1. The City of Yarra (Council) has prepared Amendment C231 to the Yarra Planning Scheme (Scheme), covering the Queens Parade Activity Centre and formalising the current Interim Controls introduced via Amendment C229 in February 2017 and Amendment C241 in August 2018. A Planning Panel Hearing is scheduled to start on 12 August 2019.

9. On 2 July 2019, I was engaged to prepare an Expert Witness Statement regarding urban design matters related to Amendment C231, with particular reference to the built form controls in the proposed DDO16. I am to consider two versions, the Exhibited Version and the Preferred Version prepared by Council and adopted on 28 May 2019 as its formal response to submissions.

Attachment 1: Exhibited & Preferred DDO16 / Initial Peer Review

Fig.7.4- EXHIBITED DDO controls: Queens Parade shadowing 3pm on 22 September

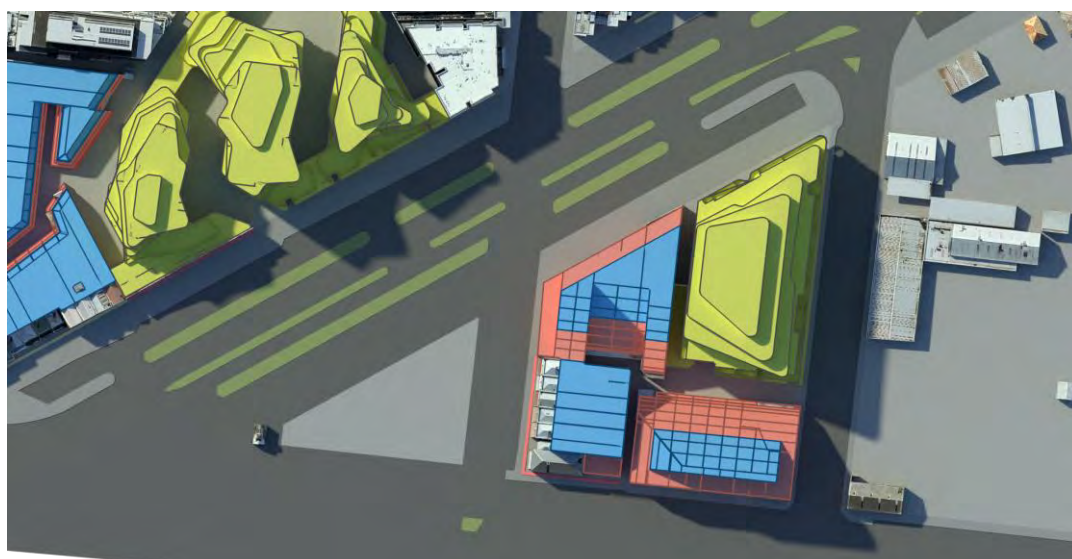
78. The Precinct 2 'Design requirements' protect solar access to Queens Parade and Napier Reserve, with a preferred shadowing restriction between 9am and 3pm on 22 September. This control is relevant to the heights along the western side of Precincts 2B and 2C to protect Napier Reserve, but Precinct 2A development at the permitted height only affects the roadway of Queens Parade, which I do not consider significant. The reference to Queens Parade solar access should be reconsidered (refer **Figs.7.3 & 7.4**).

81. The proposed controls allow the heritage terrace to be infilled behind the retained front sections with development up to a preferred height of 18m, with a setback behind the retained street wall of a mandatory 6m minimum. The Exhibited and Preferred versions are the same in this regard and in my view provide sufficient protection for amenity and character bearing in mind the development's commercial use. However, I believe the overall 18m height should be a mandatory maximum given its relationship to a heritage frontage half that height, and due to the overshadowing of Napier Reserve which a greater height would begin to introduce (refer **Fig.7.3** above).

Fig.7.6- PREFERRED Precinct 2C + permit with 4.5m to lane centre looking from George Street

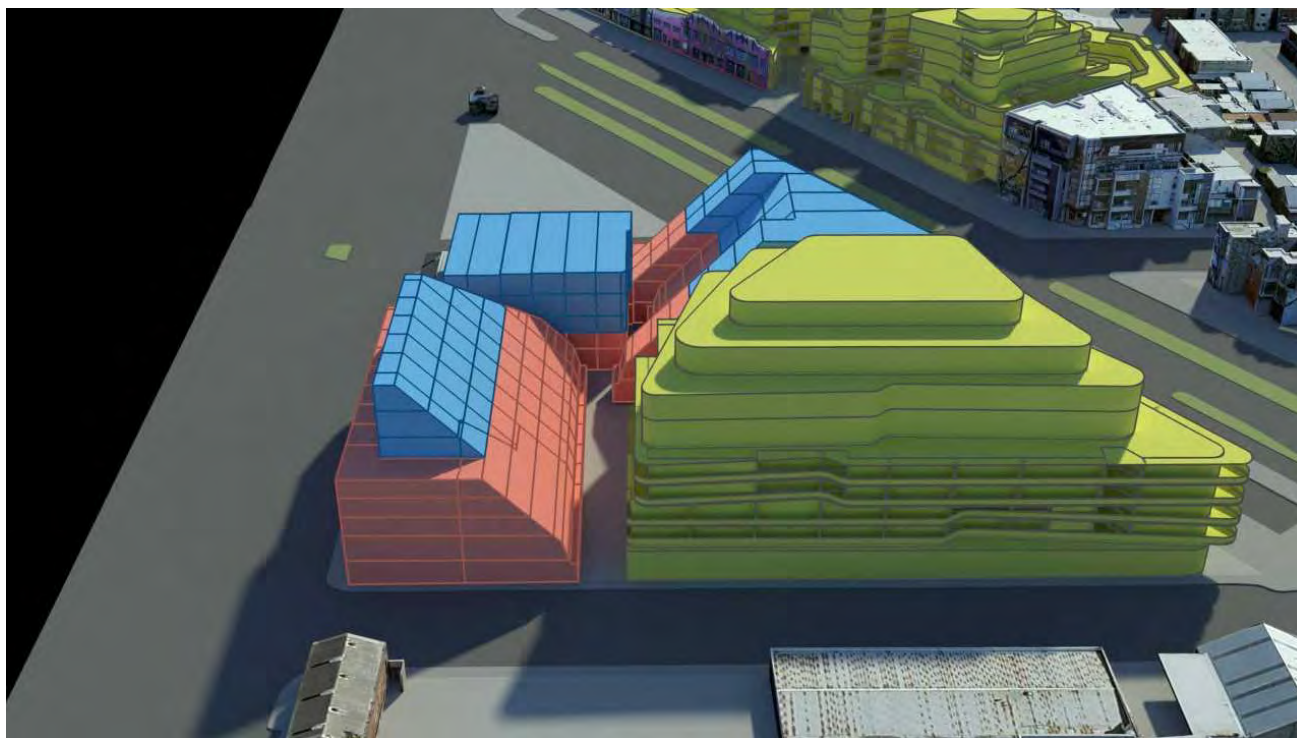
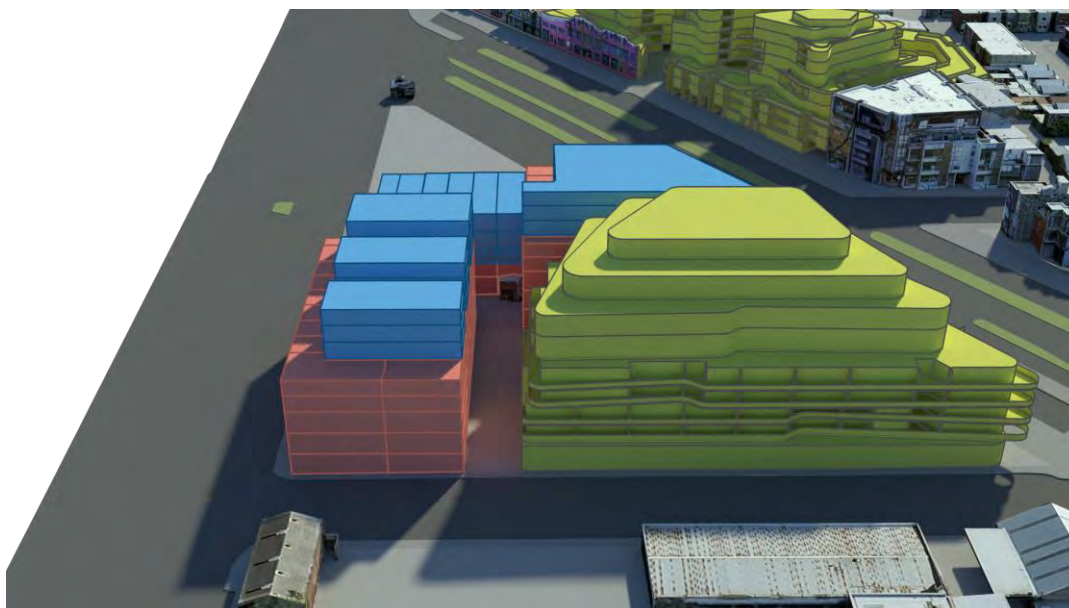
88. The Exhibited version prefers side and rear setbacks according to B17 and at 45° above a 12m height behind the Precinct 2B heritage terraces. This is unnecessarily restrictive, especially in a non-residential area (refer **Fig.7.5**). At my suggestion, the Preferred version incorporates a fixed 4.5m rear setback from the laneway centreline. The DDO indicates a preferred rear setback, but for consistency of alignment along the laneway I believe it should be mandatory. If a mandatory 4.5m setback was required to the lane centreline this would achieve an accessible 6m widened lane, even with redevelopment of only one side (4.5m setback + 1.5m being approx. half existing lane width). If both sides were redeveloped it would achieve a 9m total separation, assuring the standard measure to avoid screening. Although a commercial zone, I believe amenity in terms of direct overlooking and daylight access remains critical. Notably, the approved 81-89 Queens Parade permit already incorporates a similar rear setback (refer **Fig.7.6**).

Fig.7.7- Precinct 2C with upper level side setbacks of 4.5m above the 18m street wall (permits in yellow)

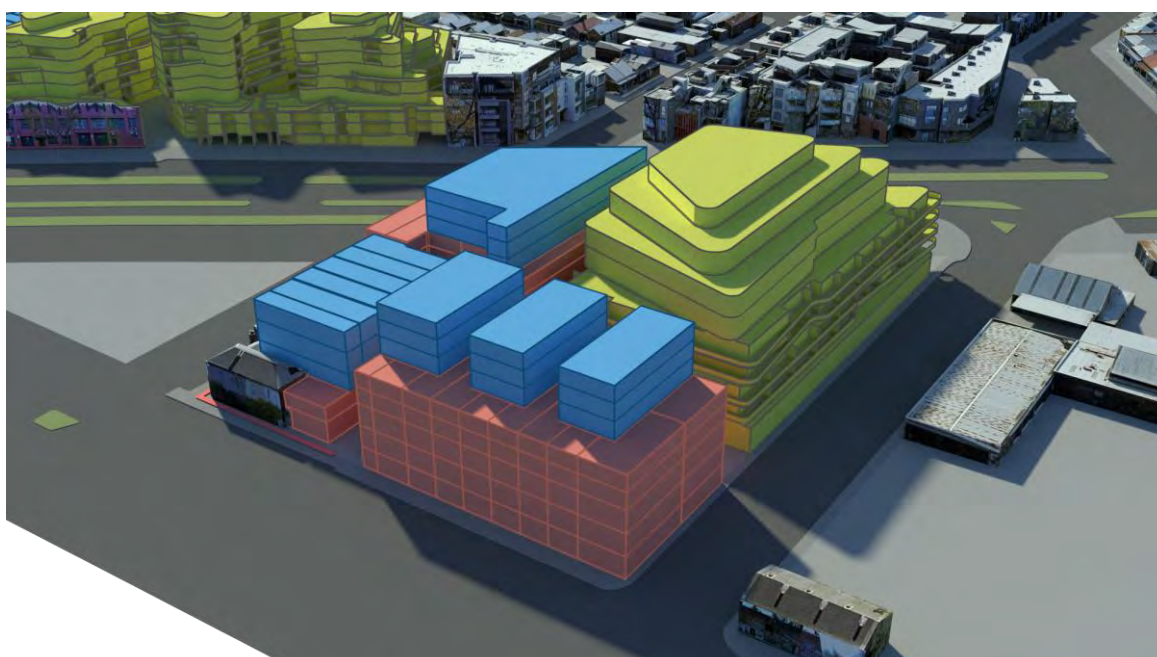
89. No lower level side setbacks are required (up to the proposed 18m street wall). However, with potentially larger buildings of around 28m height it becomes necessary to specify upper level side setbacks to secure amenity and avoid a continuous built wall. An upper boundary setback should be applied above the street wall, particularly if windows open towards the boundary. The Exhibited DDO had none but the Preferred DDO includes 3m to non-habitable or commercial windows and 4.5m to habitable windows.
90. My recommendation is for a standard 4.5m preferred upper setback whatever the window use. Uses change over time and offices require as much amenity as apartments (particularly daylight). It is also possible that only one neighbour may have windows, so the gap may be reduced to only 4.5m (refer **Fig.7.7**)

Fig.7.12- Rear setback alternatives (Exhibited and Preferred), with and without lane

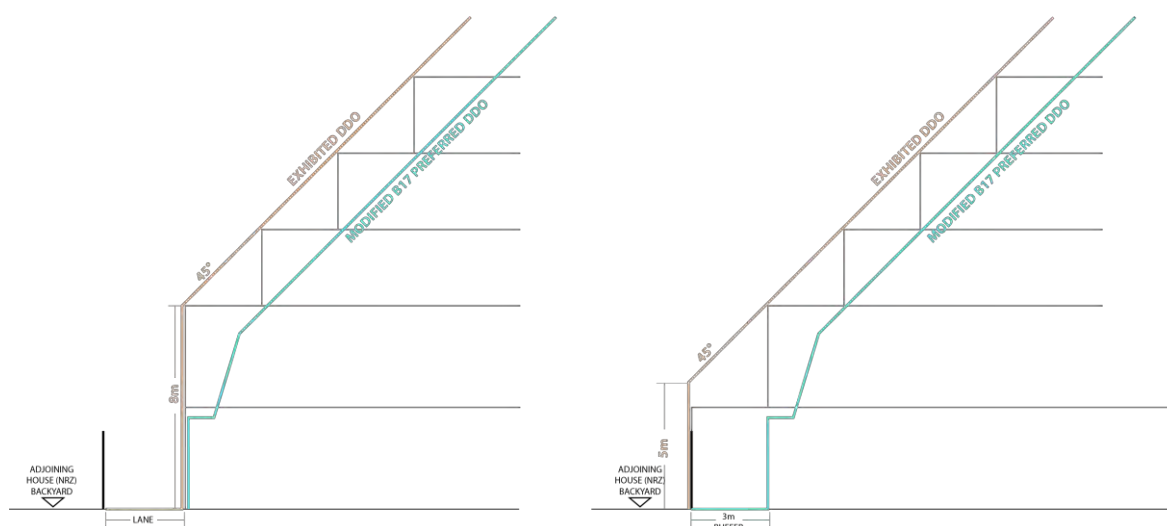
98. The rear setbacks exhibited for DDO16 were a preferred boundary wall height (8m without a lane or 5m with a lane) then above within a 45° incline. The Preferred DDO version, changes this to a modified B17 with a higher ground floor of 4m (**Fig.7.12**). This is helpfully illustrated in Figures 1 and 2 included with the DDO Schedule.

99. Importantly the requirement in the Preferred version and the figures continue to recognise whether there is a lane serving as a buffer along the interface. If there is no lane, they require a 3m ground level setback to provide the buffer space which I believe makes an important amenity contribution. I understand it is not meant to be acquired for public access but is a potential landscape space and avoids new walls directly on the boundary of residential open spaces. Whereas my initial advice supported the requirement of a buffer space of up to 6m, I now agree that 3m is sufficient, but recommend that it be a mandatory control due to the sensitive nature of the residential interface.

Fig.7.16- Precinct 4 with ANZ Bank PREFERRED: 14m height and 8m upper setback (permit in yellow)

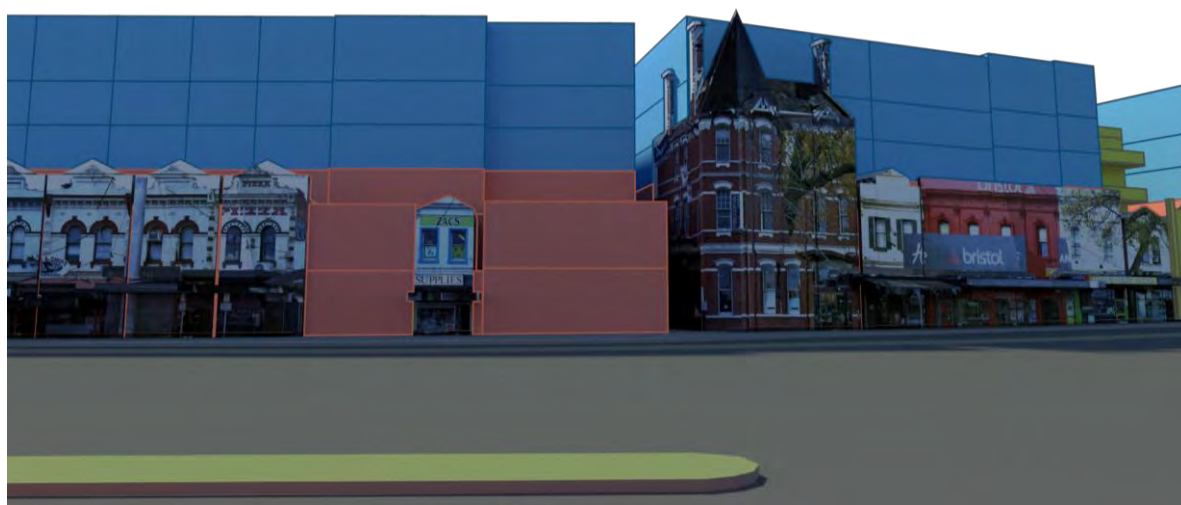
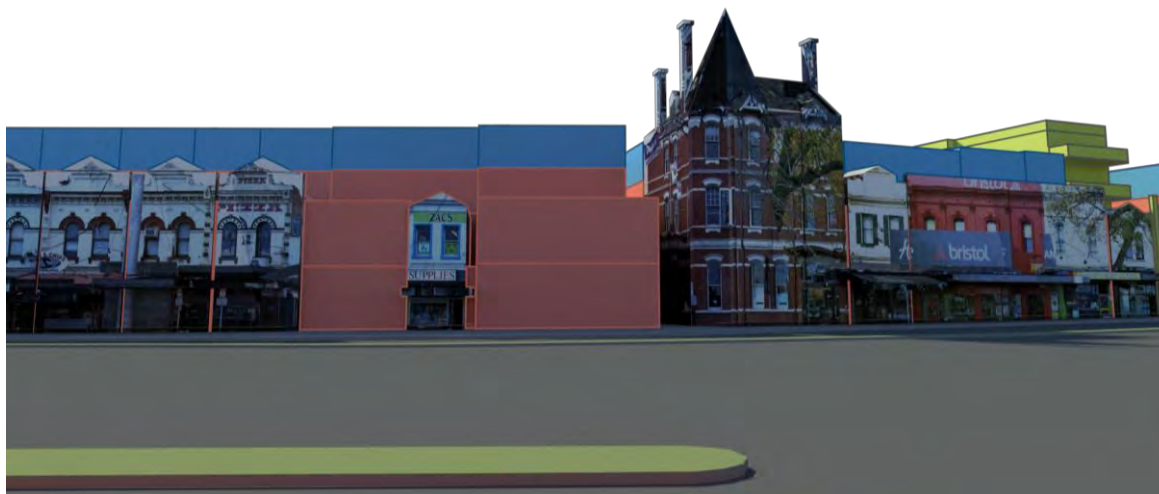
109. Following the public submissions and my initial review, Council is recommending important changes to the built form controls for Precinct 4. The overall height is to be reduced from 21.5m to 14m and the upper level setback is to be increased from 6m to 8m and become mandatory throughout (**Figs.7.15 & 7.16**).

Fig.7.22- Precinct 5 with recent construction (white), permit (yellow), applications (orange)

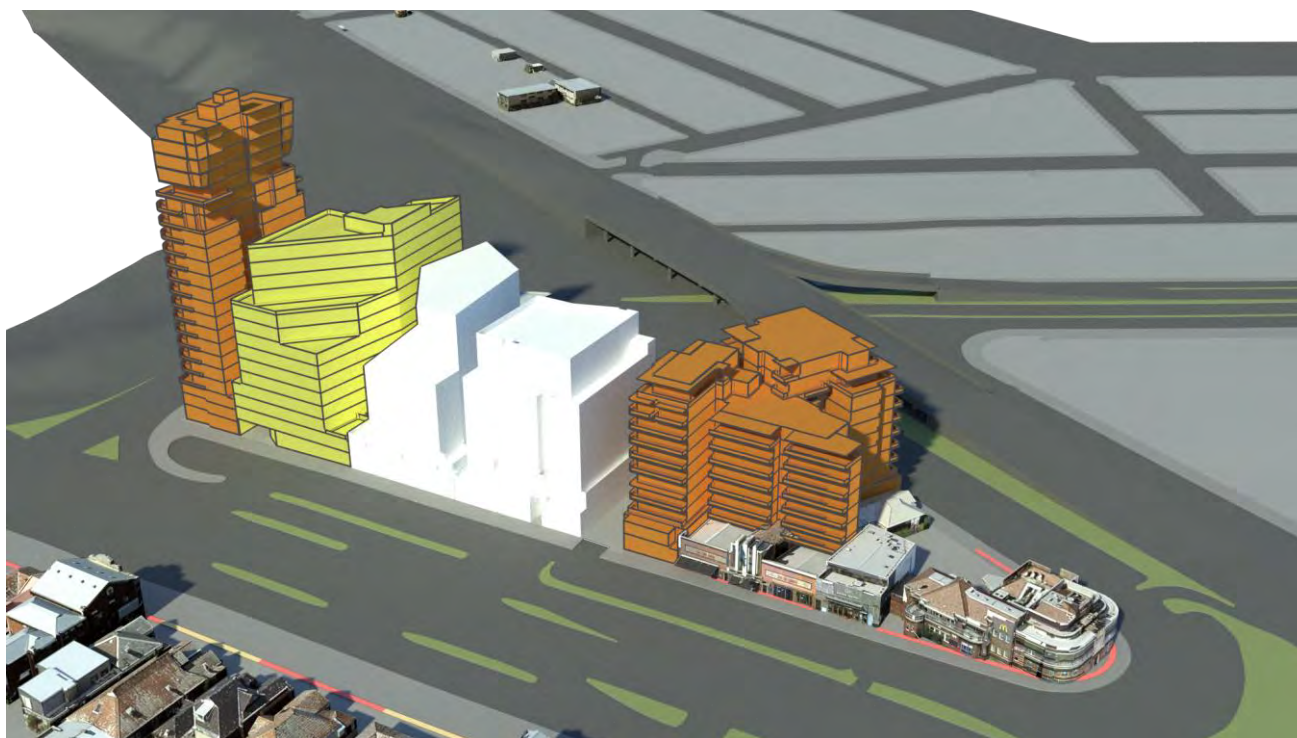
122. Precinct 5 is substantially committed with the modelling of recent construction (white), permits (yellow) and applications (orange) showing a dense, higher-rise precinct including a current application of up to 69m (22 storeys). There are no major amenity impacts in this location, except potentially wind, and the threat to the visual integrity of the Former UK Hotel (now McDonalds) and the Clifton Motors frontage. The proposal for the Clifton Motors' site already has heritage approval but not a planning permit (refer **Fig.7.22**).

Fig.7.25- Precincts 5B (left, with 18m & 28m heights) and 5A (right, with 11m infill)

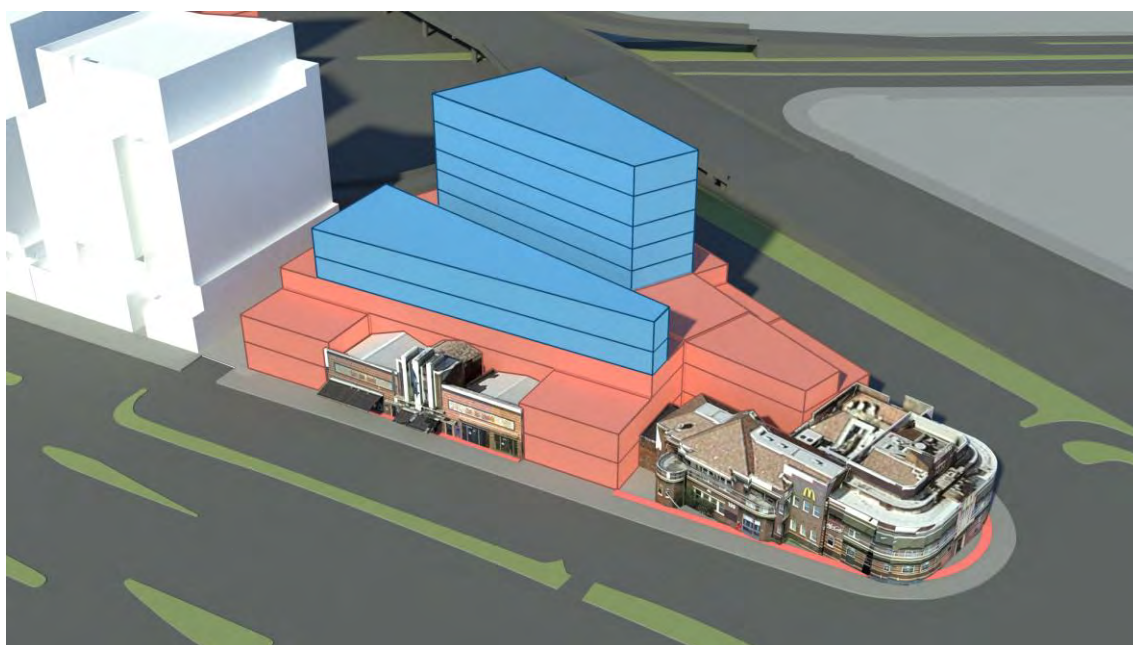
128. As noted above, the Clifton Motors site already has a proposal which is approved by Heritage Victoria (though without an approved planning permit) and which does not comply with the Exhibited 1:1 ratio for visible upper development, having a 10-storey building behind the low deco façade. Hence, I recommended this complex requirement be deleted and the Preferred DDO replaces it with stepped overall heights of 18m to Queens Parade and the unchanged 28m to Dummett Crescent in the rear (**Figs.7.24 & 7.25**).

129. The Exhibited requirement of a mandatory setback of 6m behind the retained Clifton Motors façade with matching adjoining street wall height has been increased to 8m in the Preferred DDO. This is commensurate with the greater setback applied to significant heritage in Precinct 4.
130. Elsewhere, the 6m setback is preferred, above the preferred 11m street wall height. I agree, the street wall height could be discretionary in this case, but its upper setback should be made mandatory to ensure consistency and a clear visual separation.
131. Although much of 5B is amalgamated as one development site, as noted in the Precinct 5 General Requirements, it is important to include a requirement for tower separation, nominally 4.5m from site boundaries above the street wall or 'podium' height. As noted above, I support a standard 4.5m rather than a use dependent 3 or 4.5m.

Fig.7.27- Precinct 5C PREFERRED: 43m overall height, 18m street wall

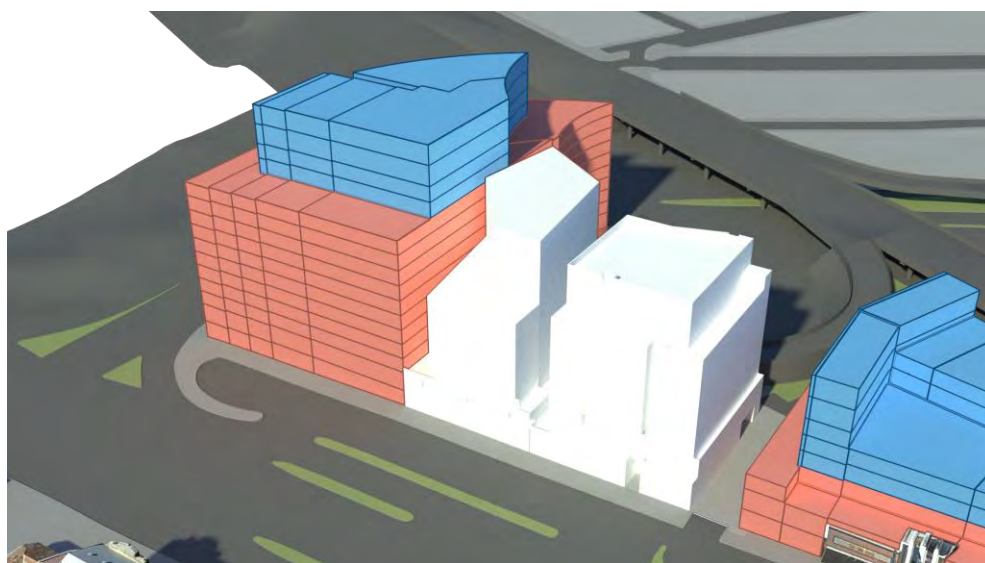
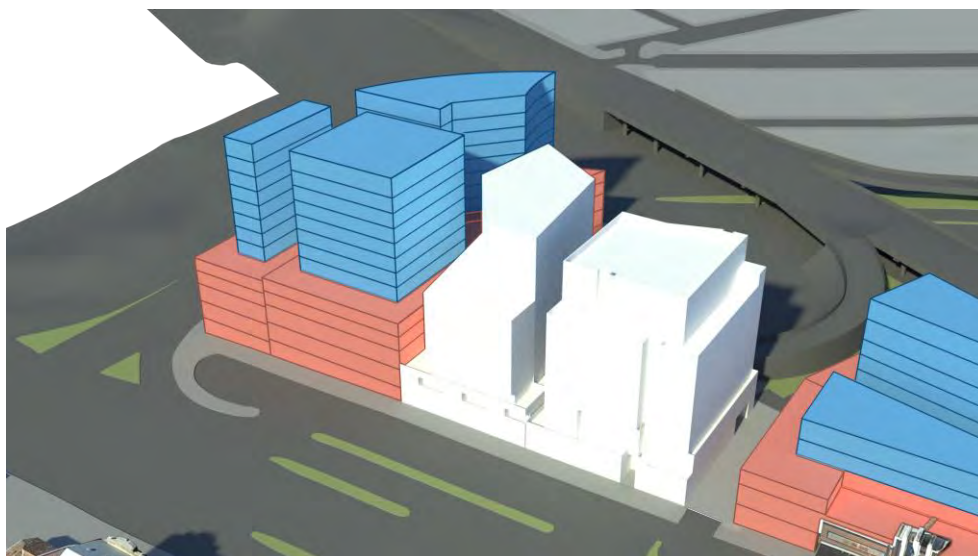
133. There are already two constructed towers up to 12-storeys, with a 22 -storey (64m) application adjoining, compared with a preferred 49m maximum height in the Exhibited DDO. The Preferred DDO reduces this to 43m discretionary height but there is no strong justification for locking in an absolute overall height, except that it closely matches the permit for 249-265 Queens Parade. Precinct 5C has no direct heritage interface and no specific overshadowing issues except for the on-ramp circular space which is of no current public utility. Therefore, the proposed 43m height provides an upper height similar to the constructed towers. I believe this height is a reasonable benchmark but does not need to be mandatory (refer **Figs.7.26 & 7.27**). A well designed tower might continue the upward transition further to the east, but the extra height should be justified by the specific design and not be regarded 'as of right'.

134. The Exhibited DDO includes an extremely high 35m street wall height (equivalent to Central City). This height of street wall may create wind down draughts in this exposed location as well as being well above the human scale at which a pedestrian relates to podium activity. Existing tower street walls are already 24m high, so the Preferred DDO reduction to 18m preferred maximum is supported to capture any new or revised permits.

Fig.5

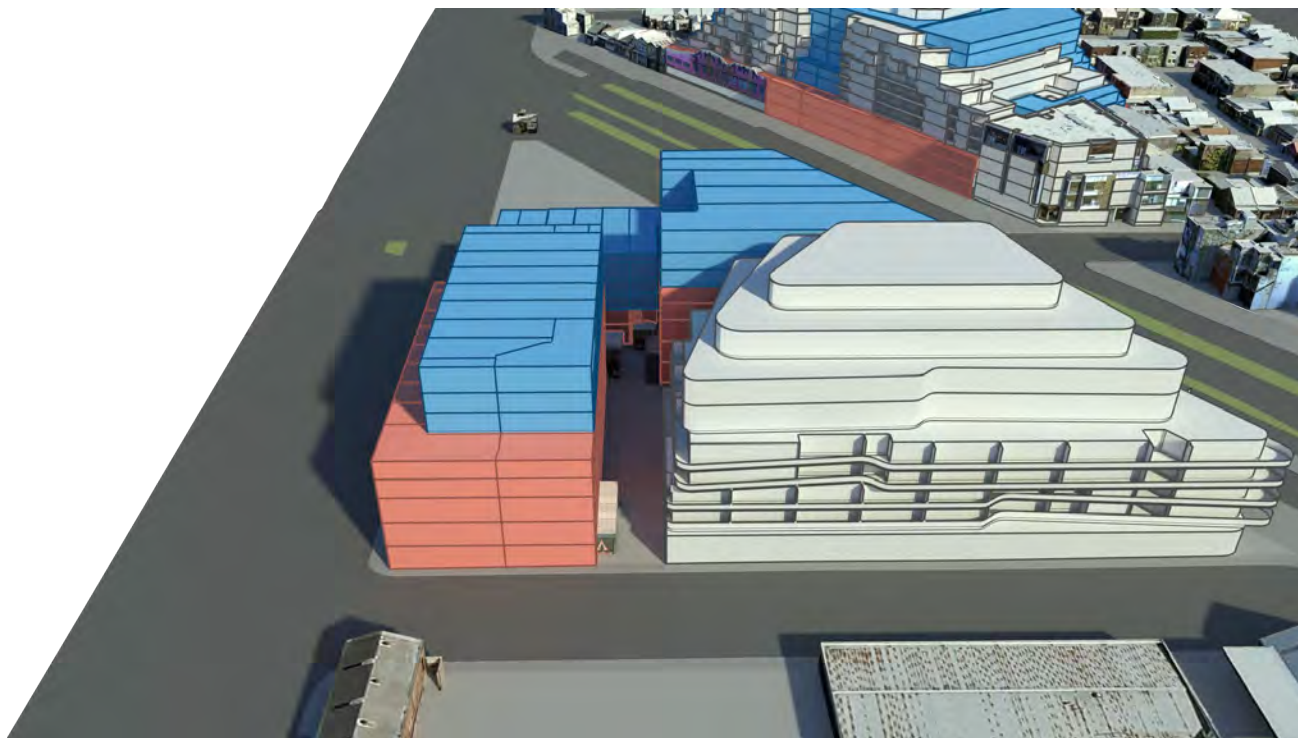
The side and rear setbacks are specified as B17, except to the interface of the Precinct 2D heritage properties where a 12m boundary wall then 45° above, is preferred. With the larger site, mid-rise

development proposed, these angled setbacks make limited sense and a direct rear setback to lanes would be more appropriate, as has been approved at 81-89 Queens Parade. If a mandatory 4.5m setback was required to the lane centreline this would achieve an accessible 6m widened lane, even with redevelopment of only one side (4.5m setback + 1.5m being approx. half existing lane width). If both sides were redeveloped it would achieve a 9m total separation, assuring the standard measure to avoid screening (refer Fig.5 with 4.5m rear setbacks to lane centrelines, including 81-89 Queens Parade permit).
